Planning Commission Regular Meeting

Monday, November 24, 2025, 6:30 PM
106 Center Street

ITEM REPORT**To:** Planning Commission**From:** Julia Mullin, Community Development Director**Meeting Date:** November 24, 2025**Department/Office:** Community Development**Item Name:** 174 West Lake Street Residential Review Permit and Variance Applications (PC No. 2025-09) - *continued from 11/10/2025 Planning Commission meeting***Summary:**

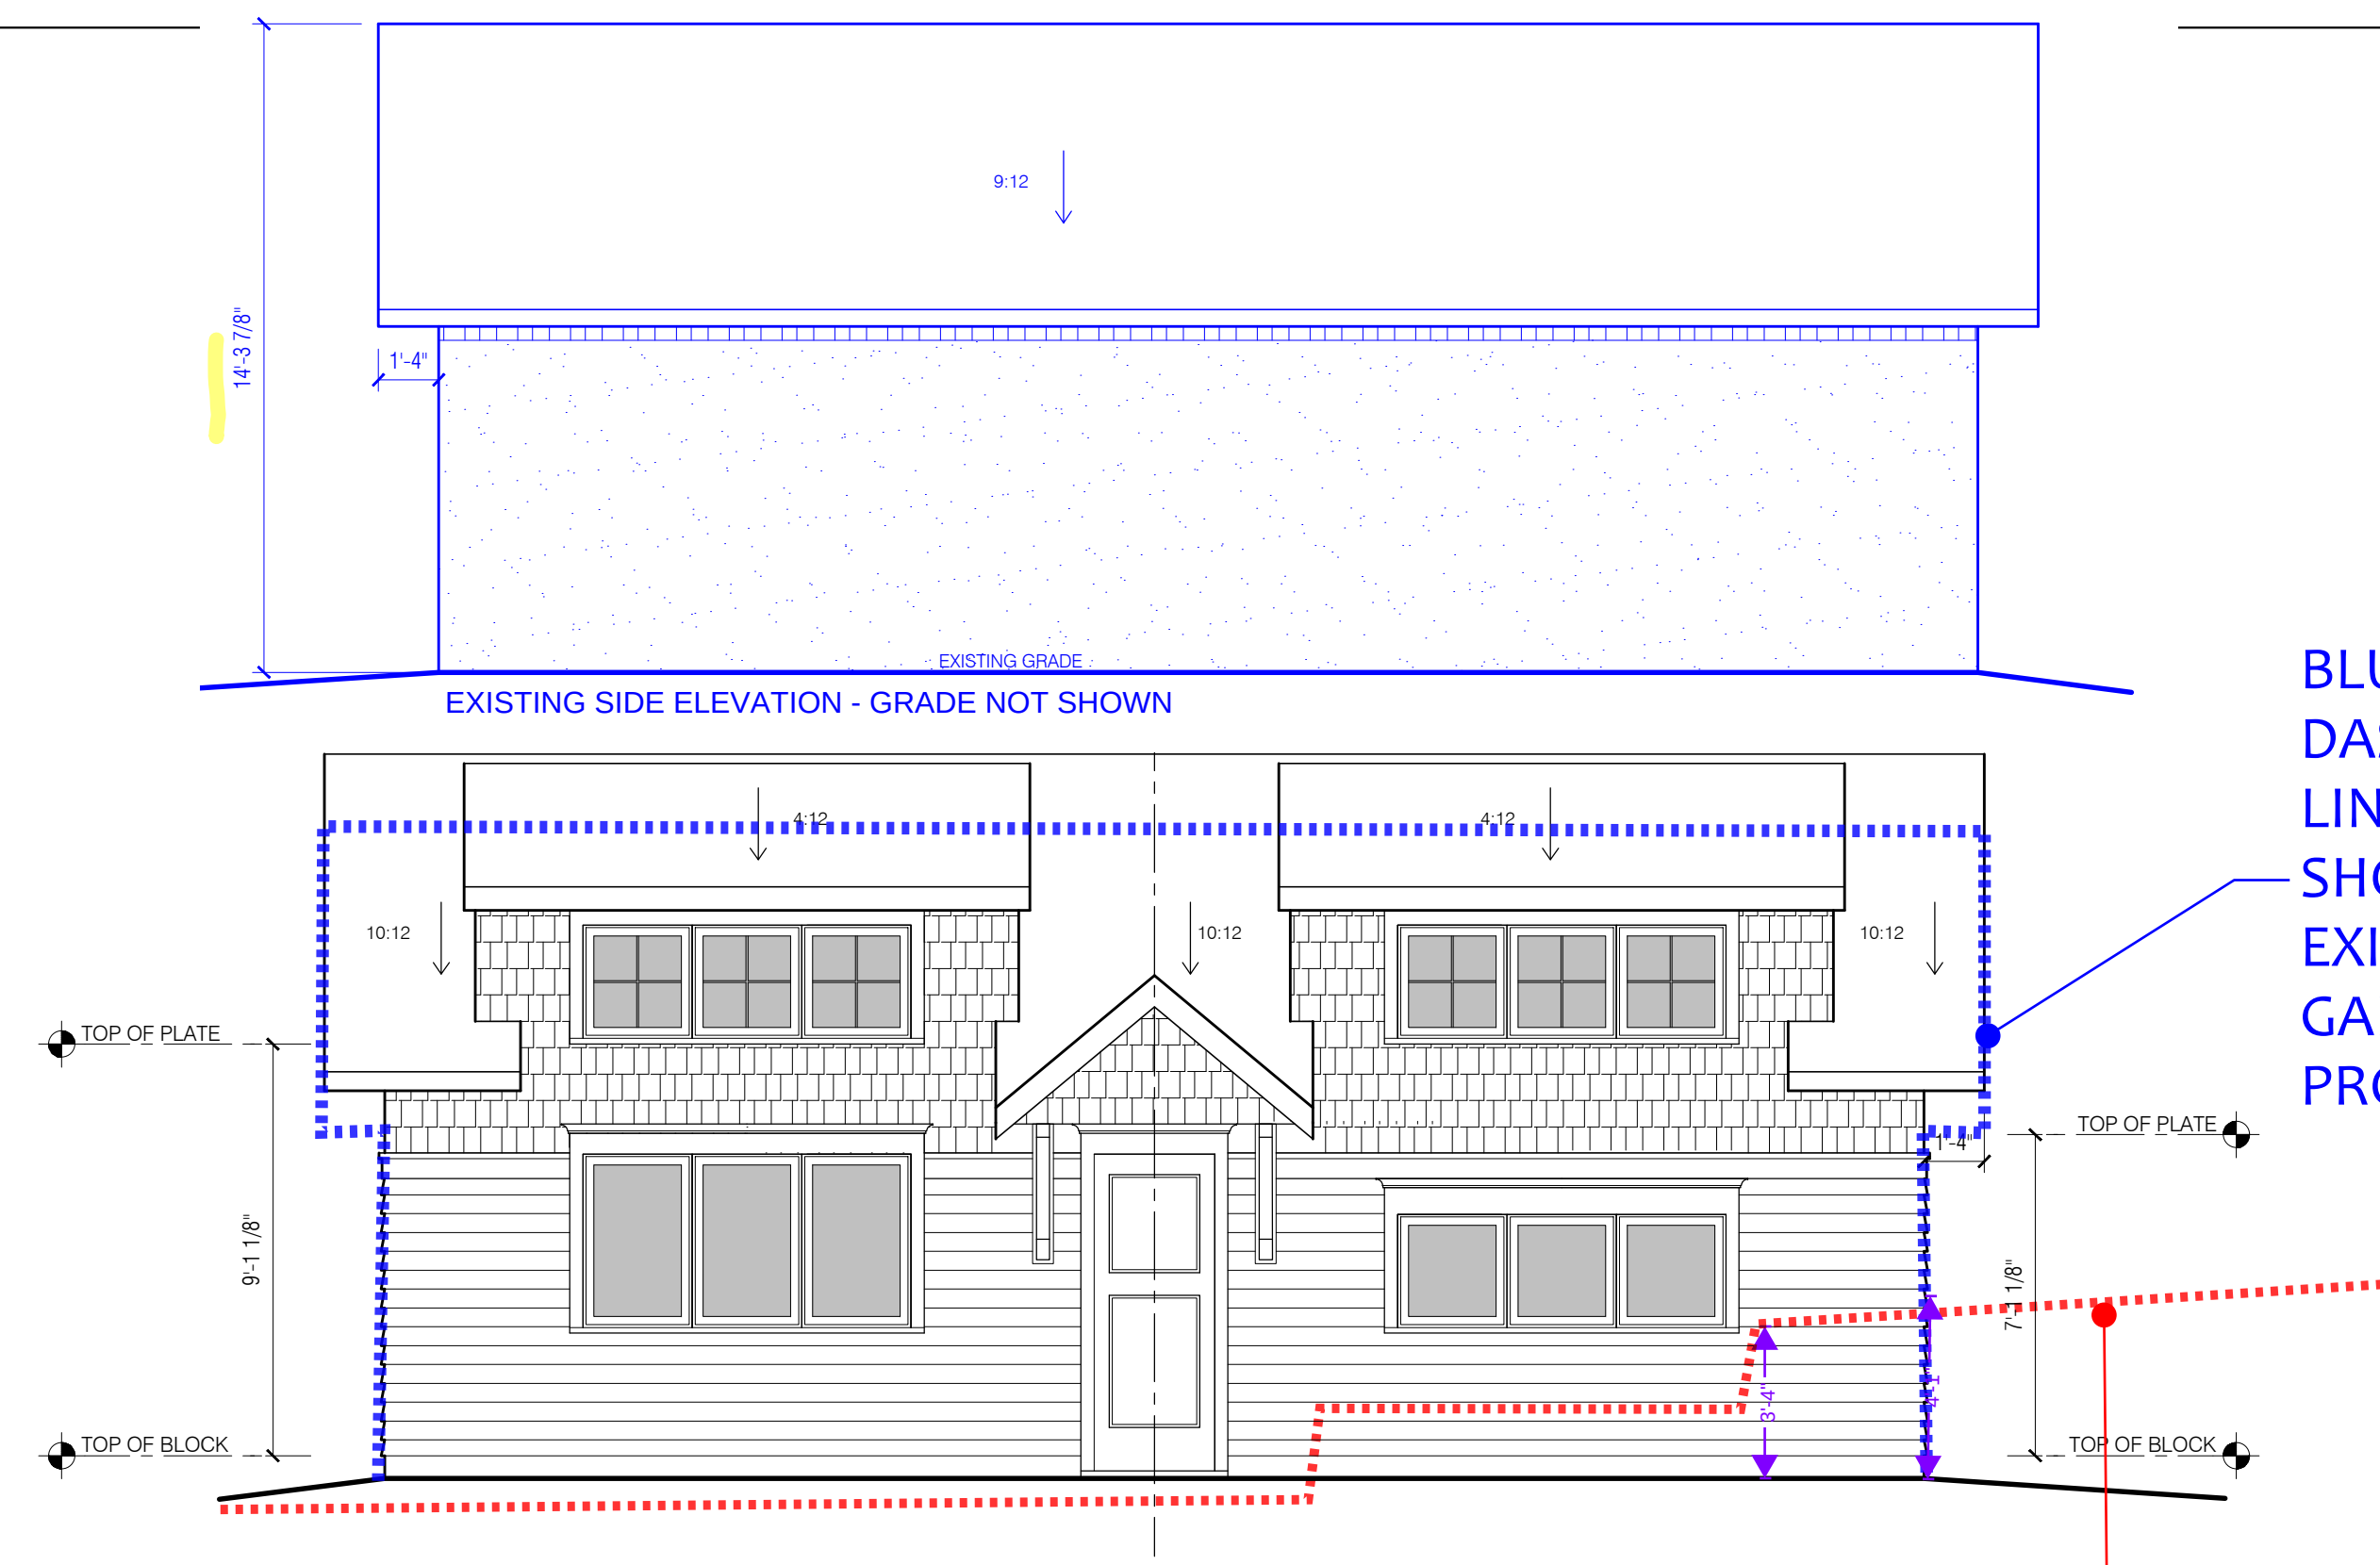
The project proposes demolition of an existing garage and construction of a new garage. The existing garage extends over the street side property line about 6.4 feet. The proposed new garage is pushed back an additional 4-0'. Extending beyond the property line about 2.4', it aligns approximately with the adjacent existing garage to the right at 162 West Lake Street. There are several existing garages along West Lake street that also extend beyond the front property line (***as shown in the attached aerial drawing***).

3 Side Elevation
A1.0 1/4" = 1'-0"

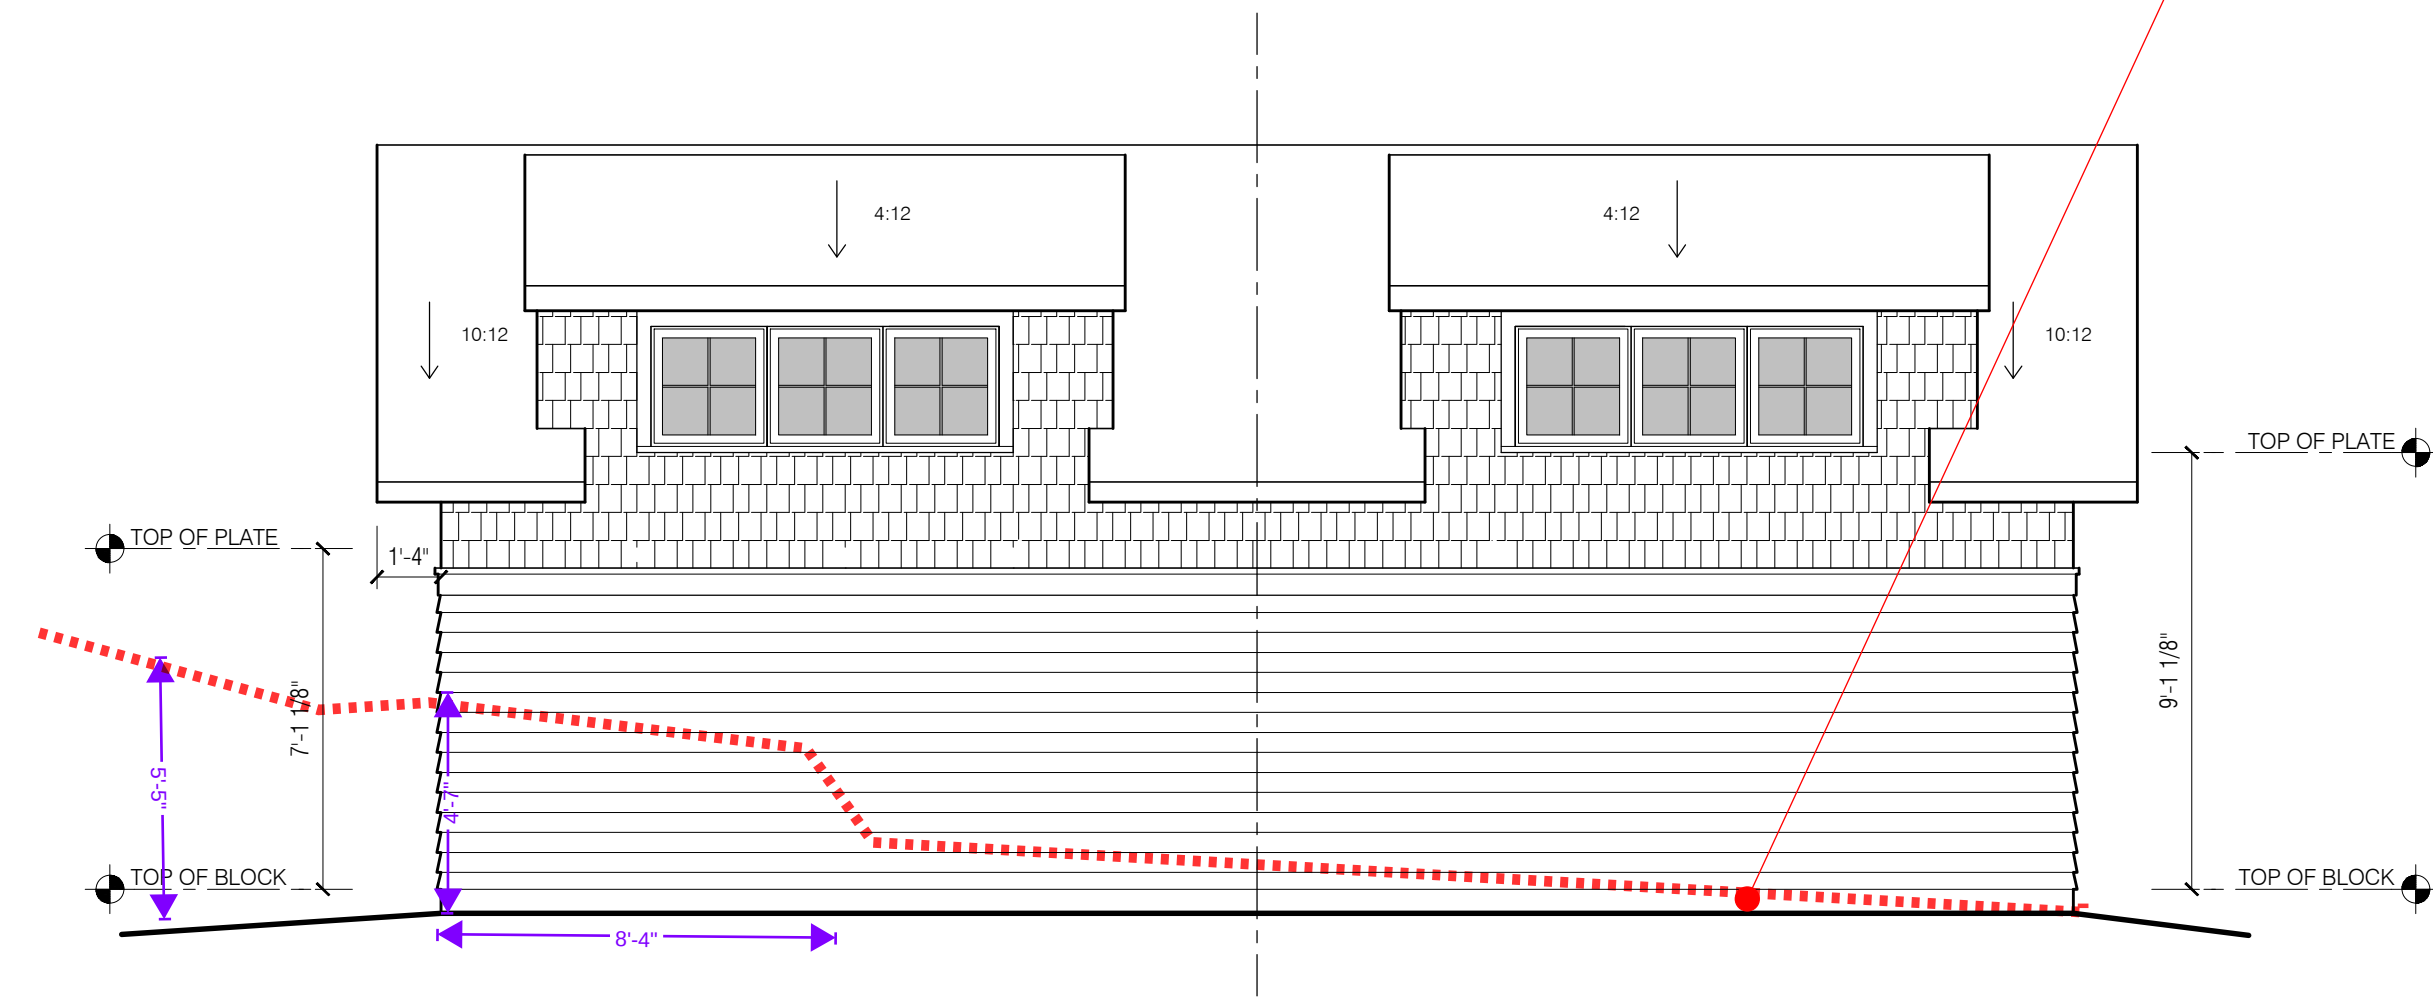
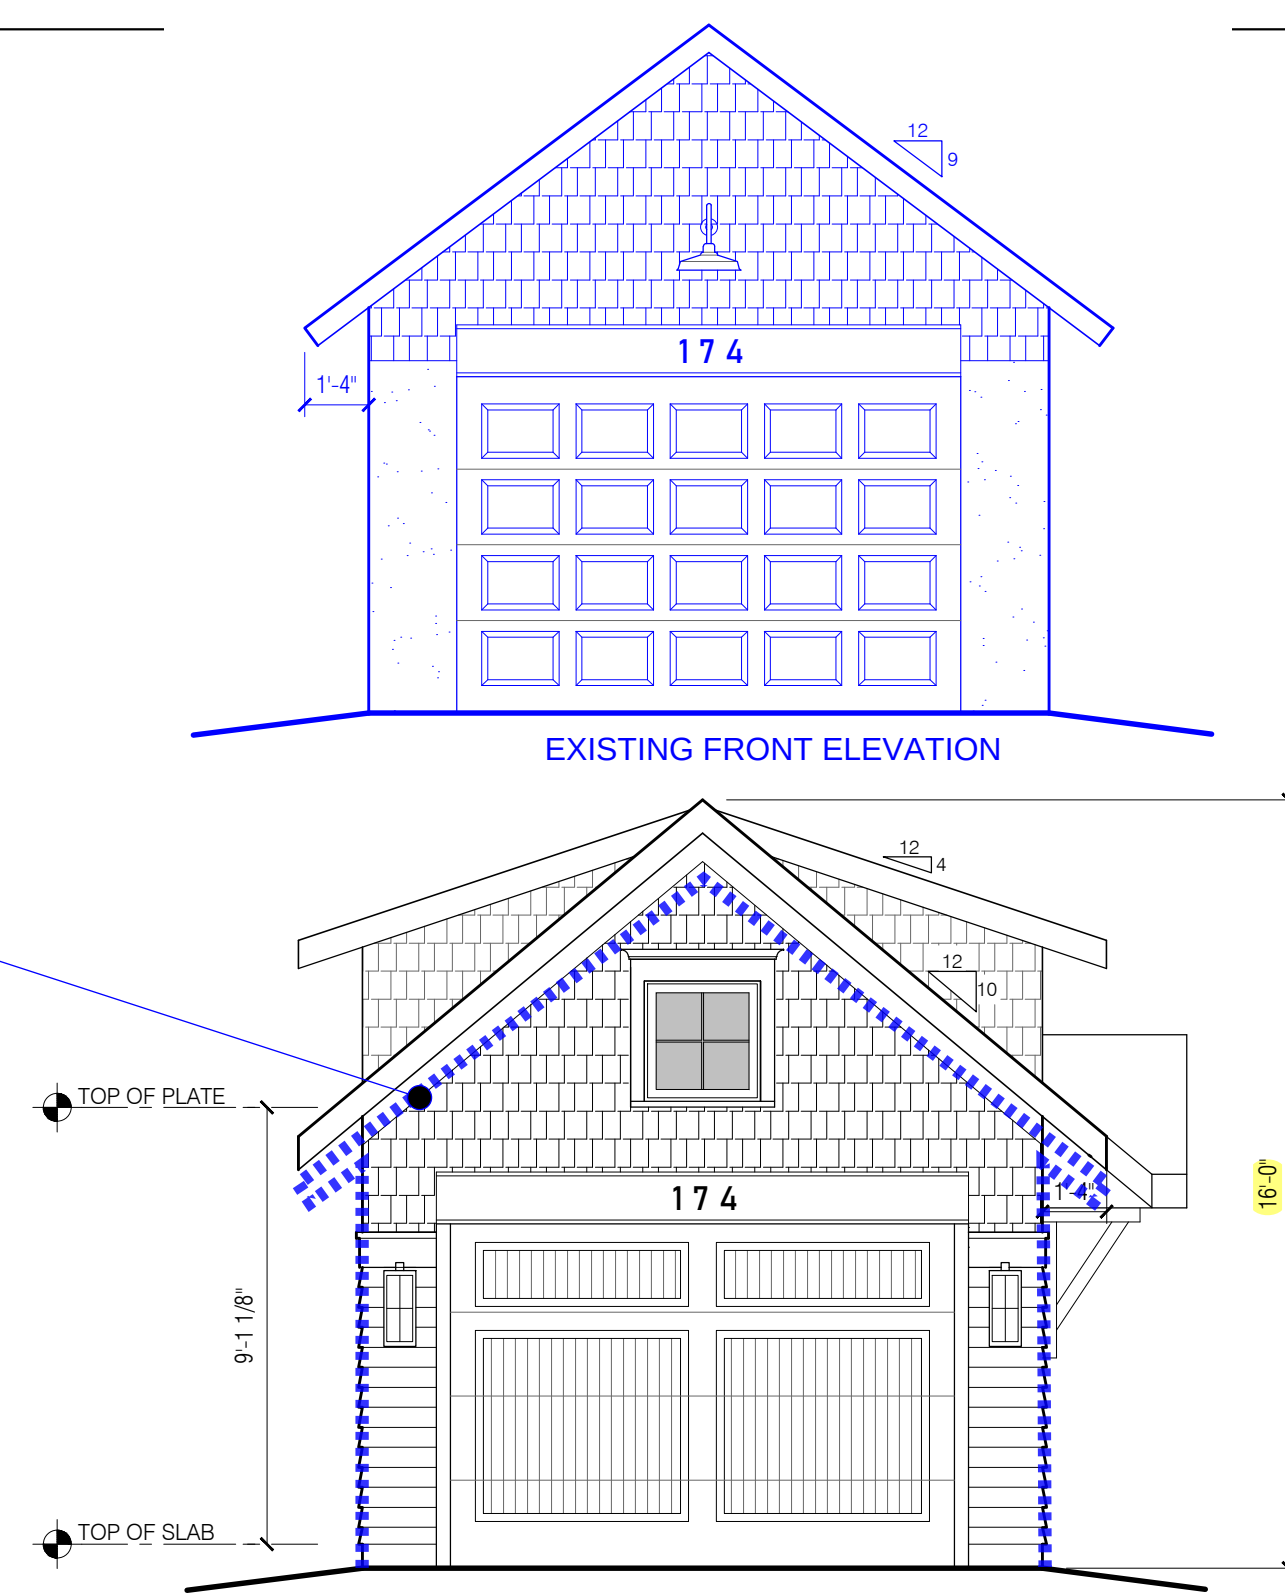
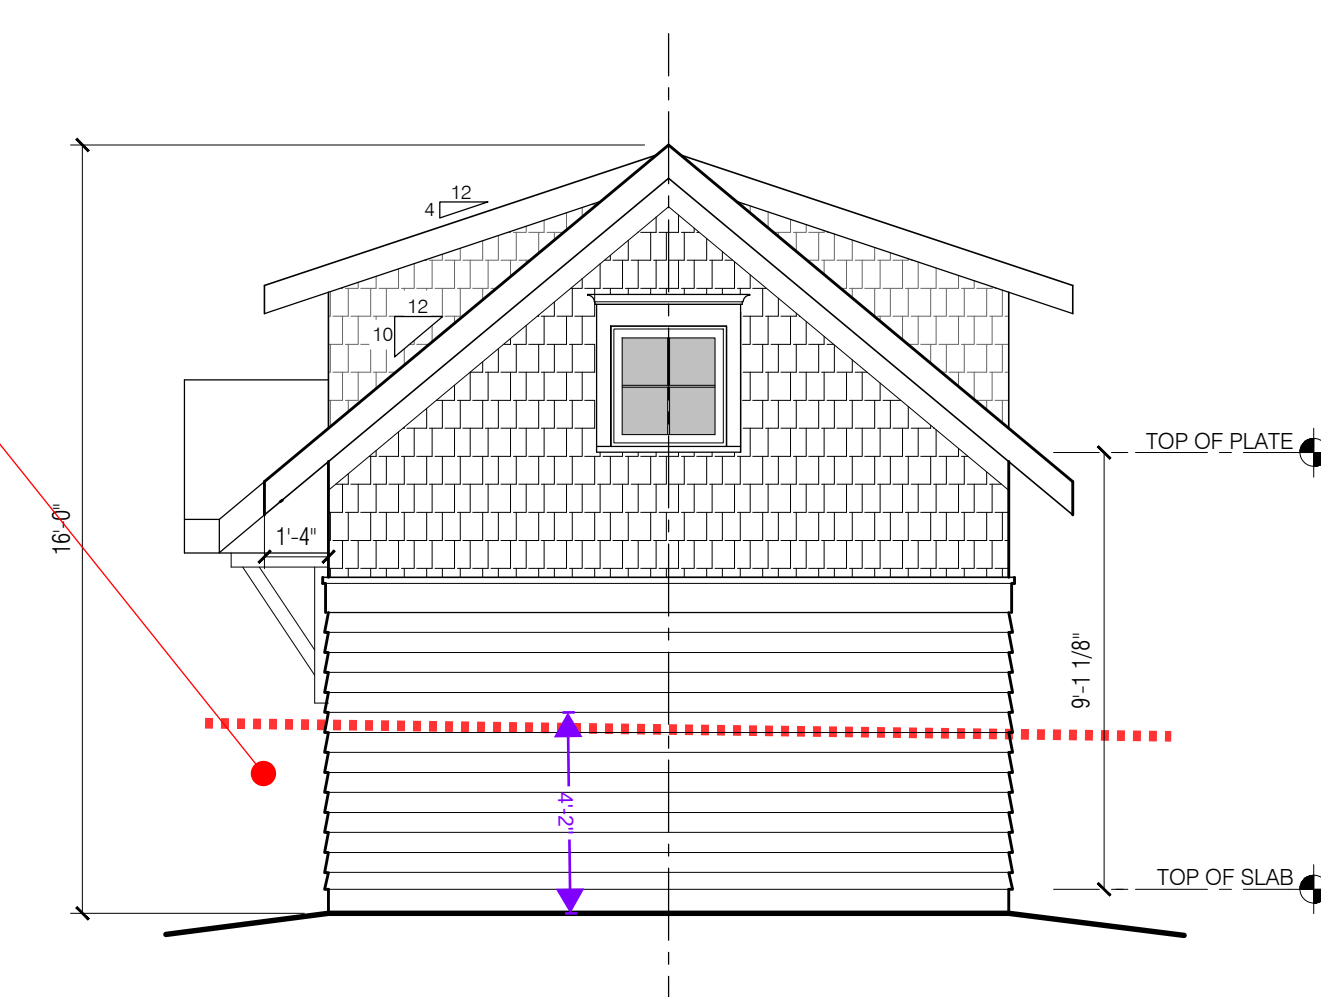
The proposed garage is comparable in massing and scale to neighboring structures on West Lake Street. The applicant has included dormers to the roof to break up the roof line and add architectural interest to the building. There is a detached garage at 162 West Lake Street with a partial second level, adjacent to the subject garage, and on the other abutting parcel there is no structure. The detached garage at 200 West Lake Street, four parcels to the southwest, is two stories.

The garage and retaining walls as proposed respond to the existing slopes. Some existing boulder retaining walls have been removed, and two small segments have been added to accommodate the relocation of the garage footprint and its side entrance.
